Supplemental Information

3368 WASHINGTON STREET

Submitted to:
Boston Planning and Development Agency
One City Hall Square
Boston, MA 02201

October 4, 2019

Landscape Plans

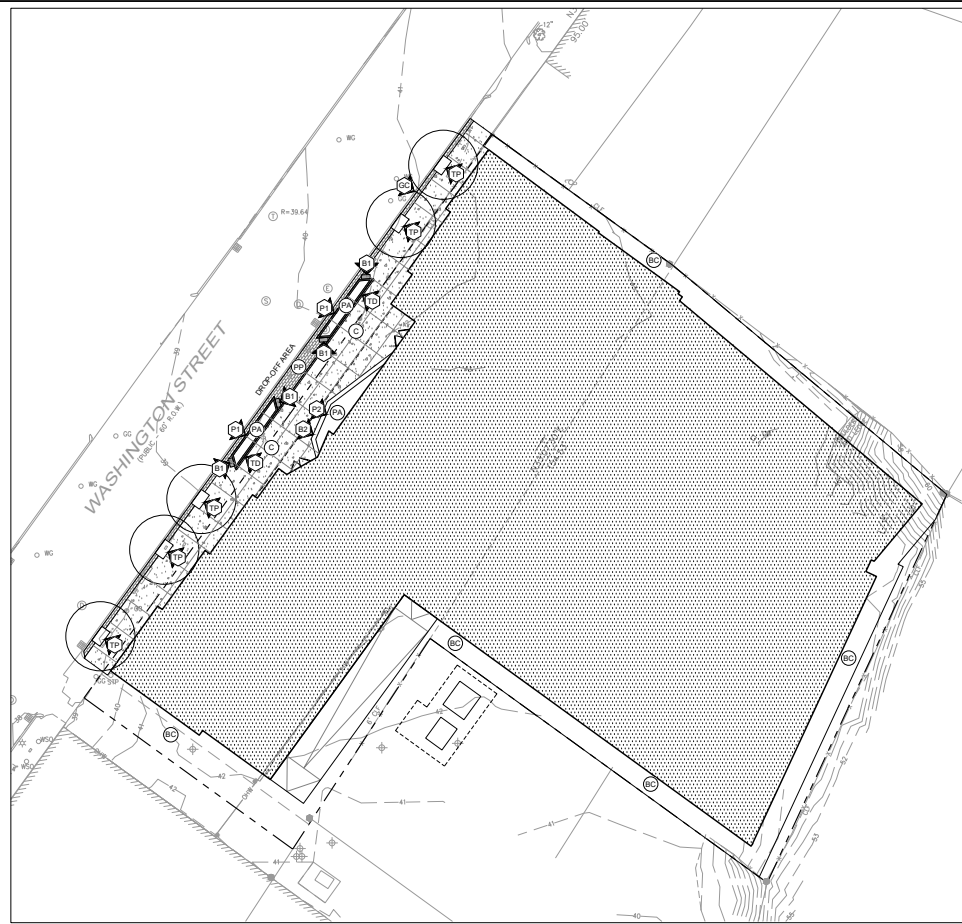
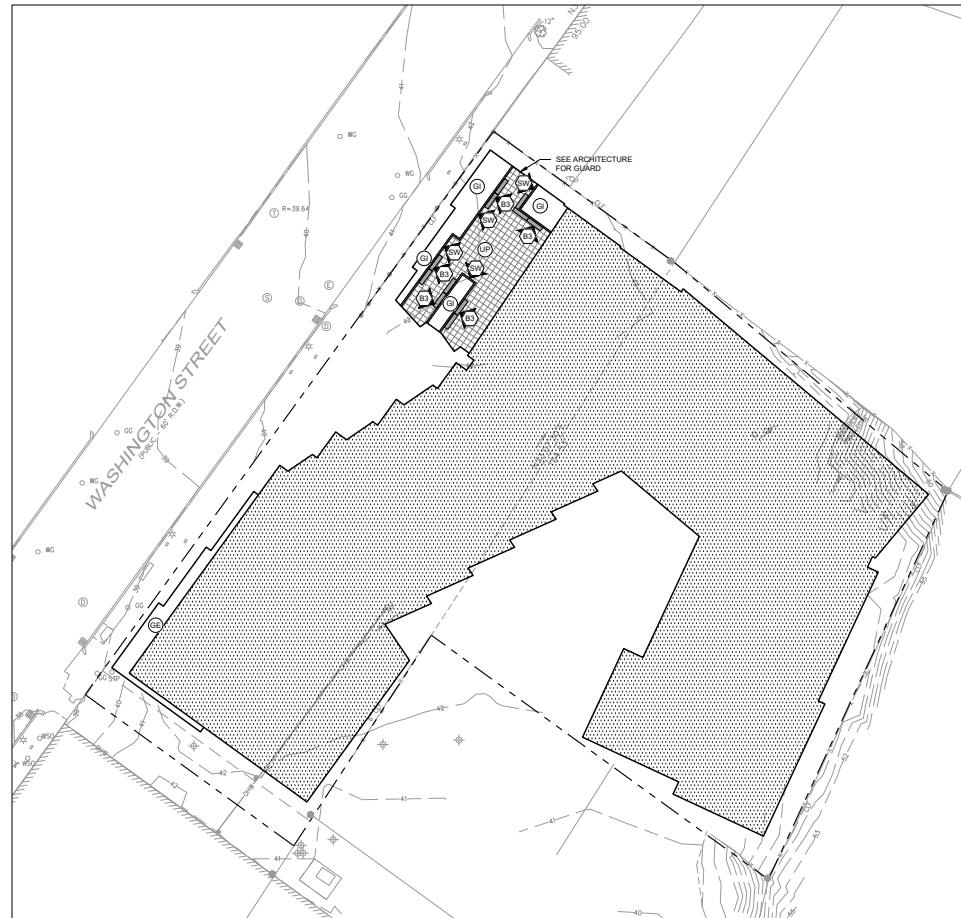
- Additionally, a more developed site and landscape plan is needed for the entire site, which will allow for further understanding of the grade issues, parking entrance ramp maneuverability, utility locations (transformer, switch, etc.), and walkways, etc. BPDA.10

JU1.2 Set the entire building back from the street by one travel lane-width to accommodate future dedicated bus lanes on Washington St, as prescribed by Plan JP/Rox on the parts of Washington closer to Forest Hills.

Sheet L-1 in Appendix A shows the landscape plan. The updated Accessibility Checklist (included in Appendix C) includes information about materials for the various sidewalk zones. Sidewalks/pedestrian zones will be cast in place concrete.

Sheet L-2 in Appendix A shows a landscape section along the entry plaza. The updated Accessibility Checklist (included in Appendix CX) confirms that the Project is meeting Boston Complete Streets Design Guidelines.

Sheet L-1 in Appendix A shows the landscape plan and sheet L-2 in Appendix A shows a landscape section along entry plaza. The driveway is 26'-6" closest to the sidewalk and increases to 28'-6" as the vehicle approaches the ramp down to the garage. This width is a standard width for a driveway.

The City has not yet created guidelines about the requirement of an additional deep setback for a bus lane, hence the additional two-foot setback has been provided per the City's recommendations. The width of the sidewalk not only complies with Complete Streets, but at key locations expands approximately 17'6" which allows for pedestrians and neighbors to have adequate room to walk along Washington Street (see Figure 1-10). There is also an additional 3'-6" buffer zone beyond the planters as shown on the landscape plan and section.

1 EW BUILDING SECTION
1/8" = 1'-0"

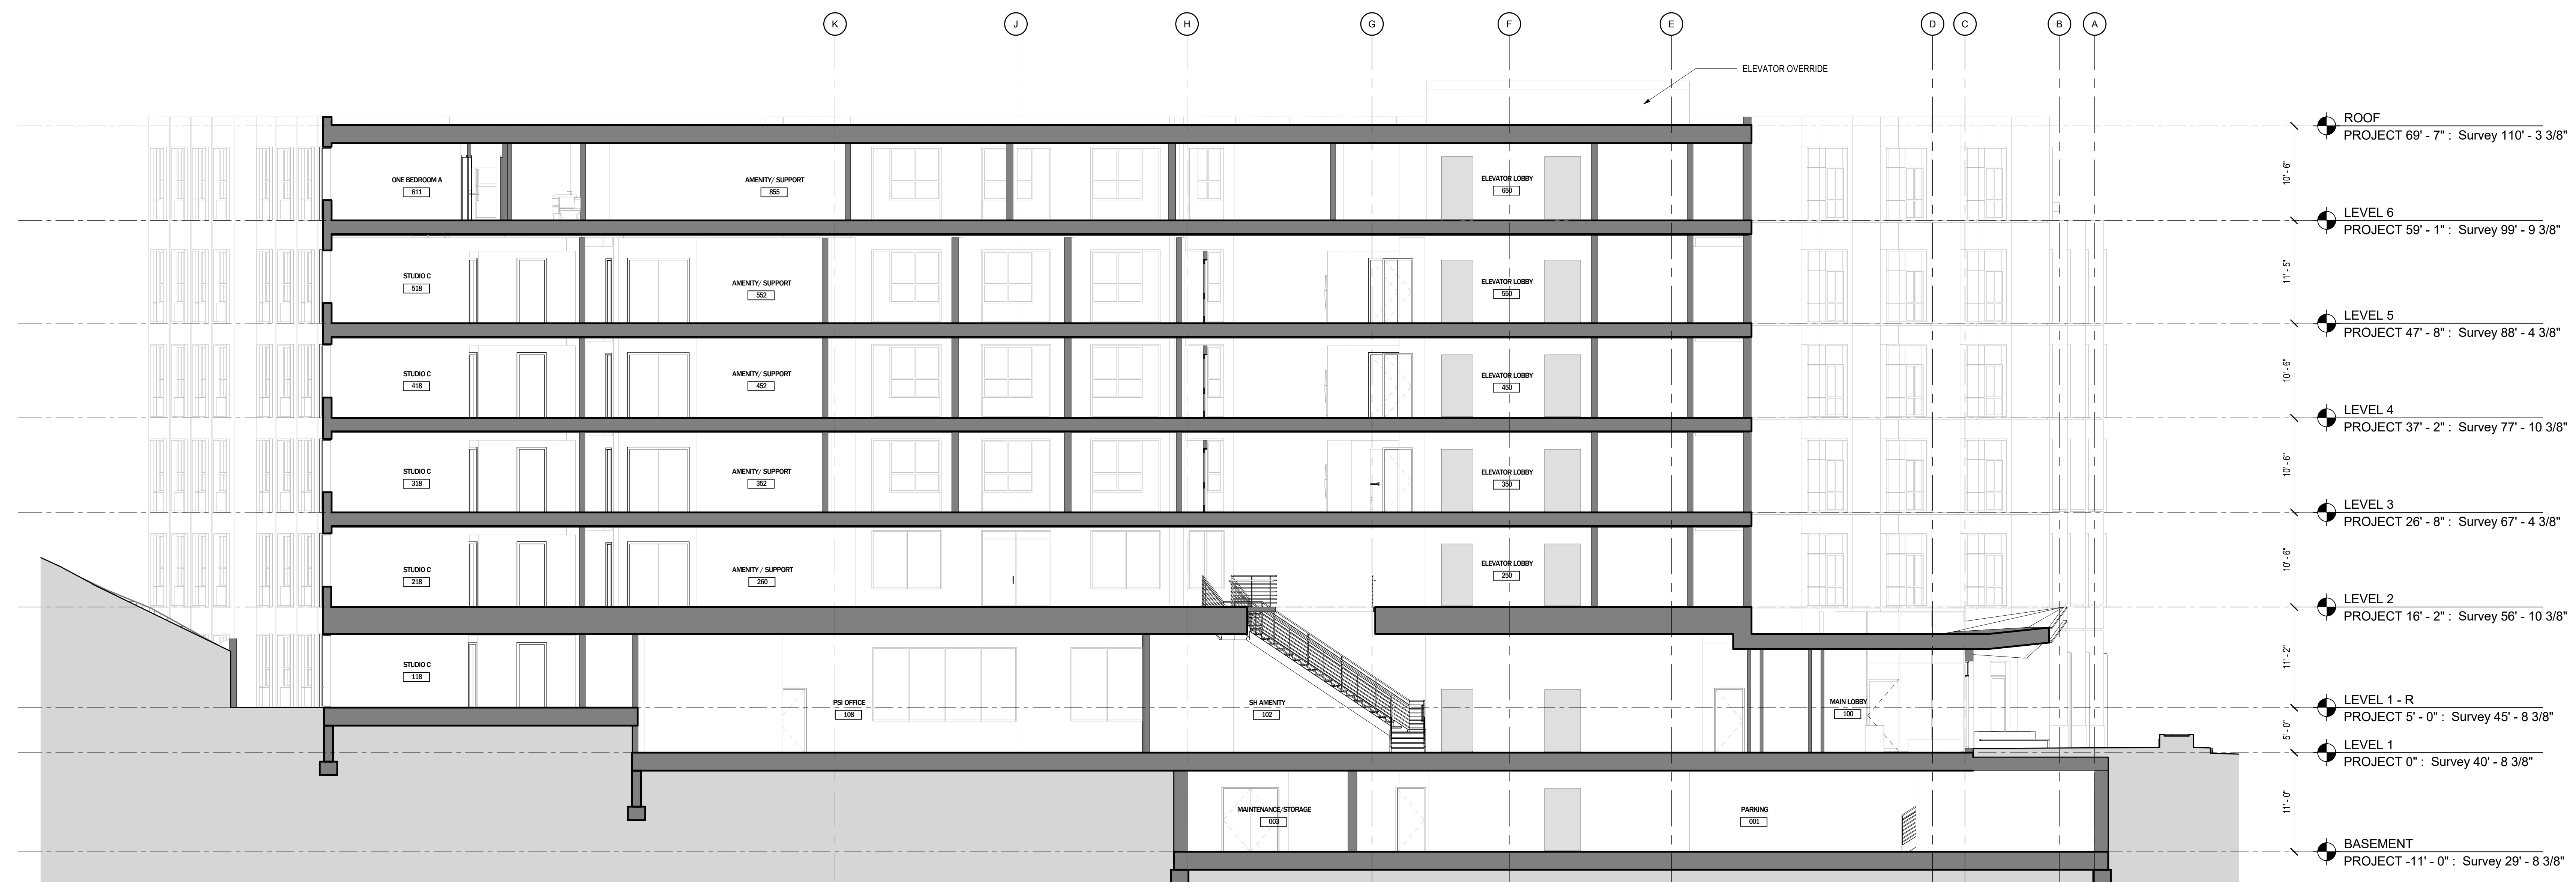
- More information is needed, however, regarding the unit layout, especially the proposed supportive housing units located on the first floor. A section drawing through the site would help to understand the relationship between these units at the rear of the first floor and the grade. BPDA.9

Sheet A-300 in Appendix D for a building section showing the relationship of the rear Supportive Housing units to grade.
